INDEX OF SHEETS

PROPOSED IMPROVEMENT INTERSECTION PROJECT TOWN OF HARTLAND COUNTY OF WINDSOR THREE CORNERS INTERSECTION

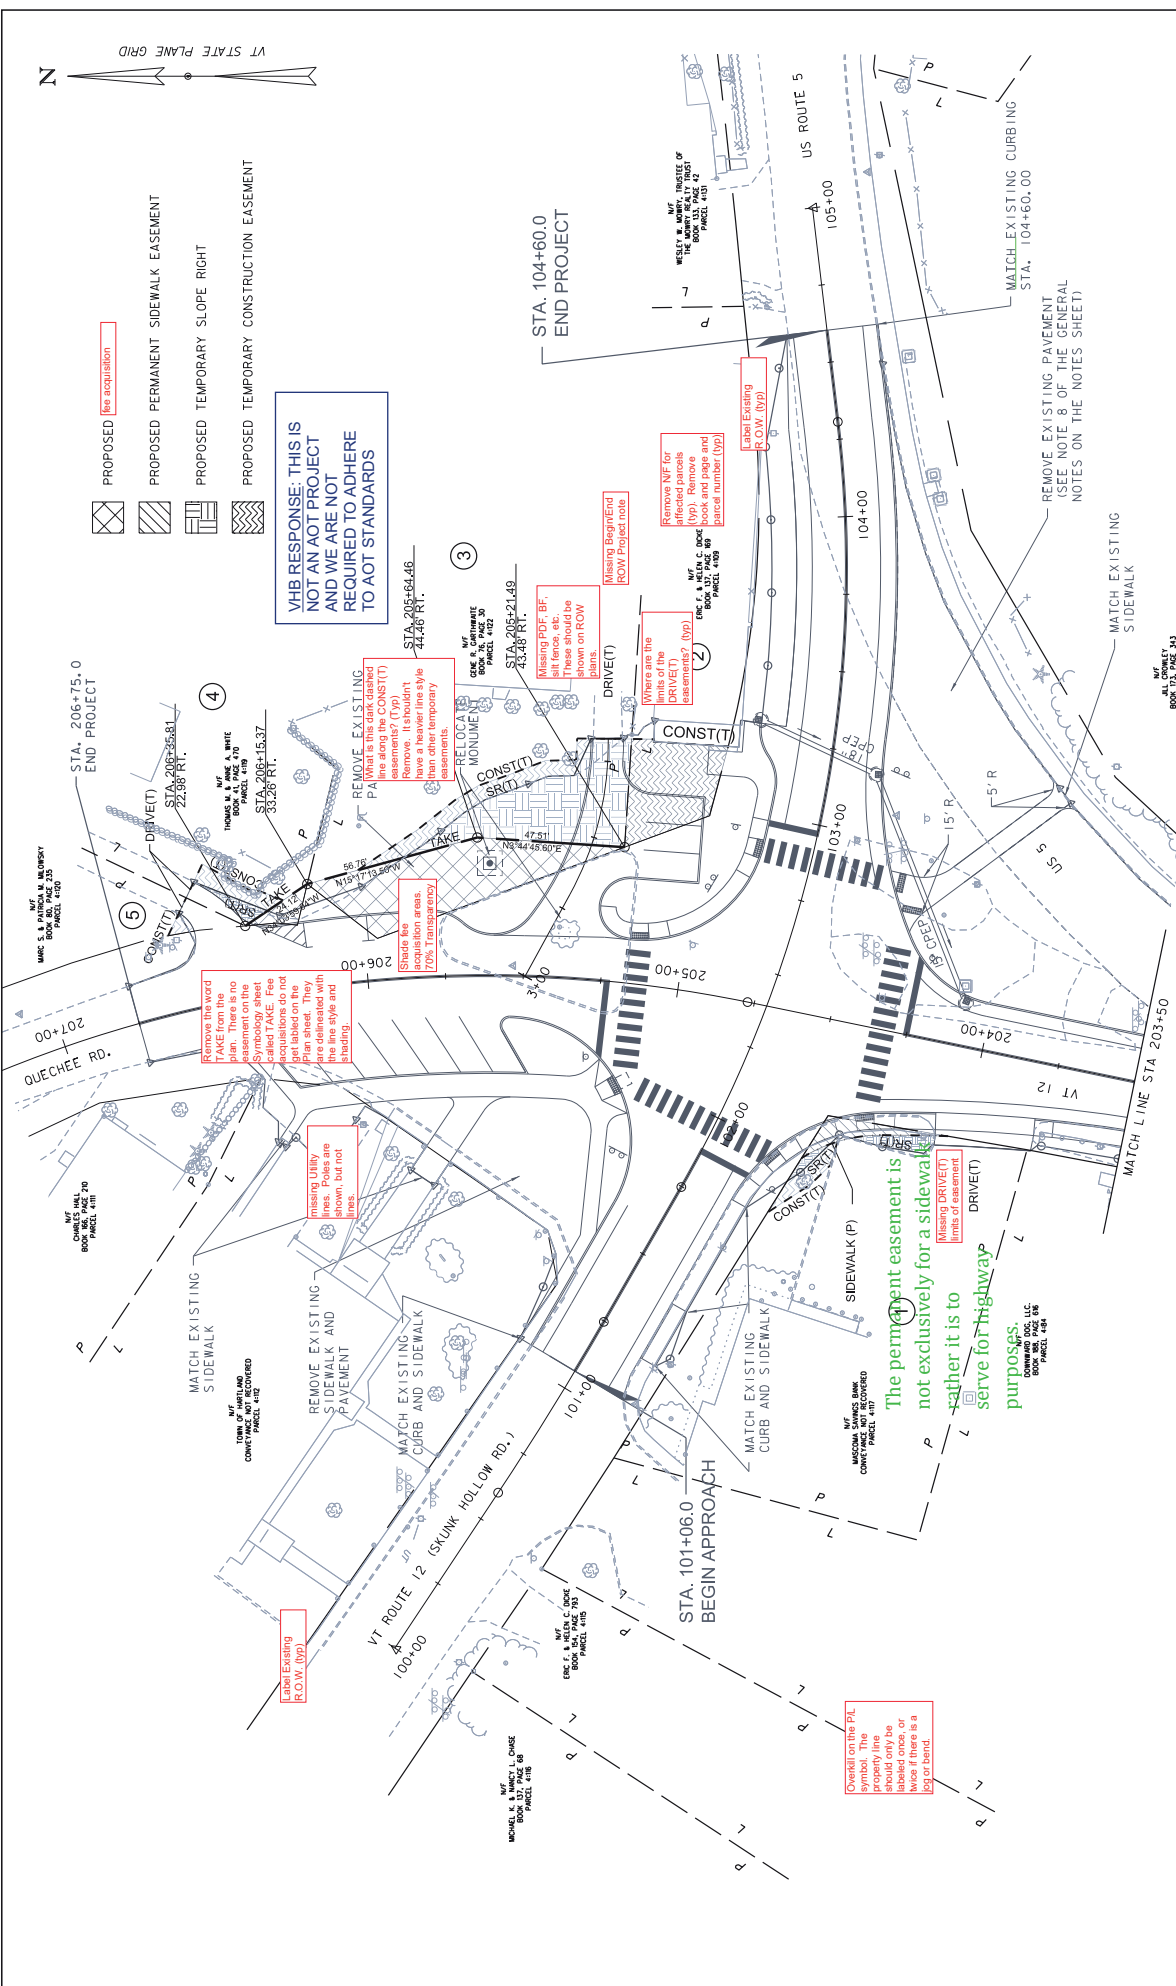
VHB RESPONSE: THIS IS NOT AN AOT PROJECT AND WE ARE NOT REQUIRED TO ADHERE TO AOT STANDARDS
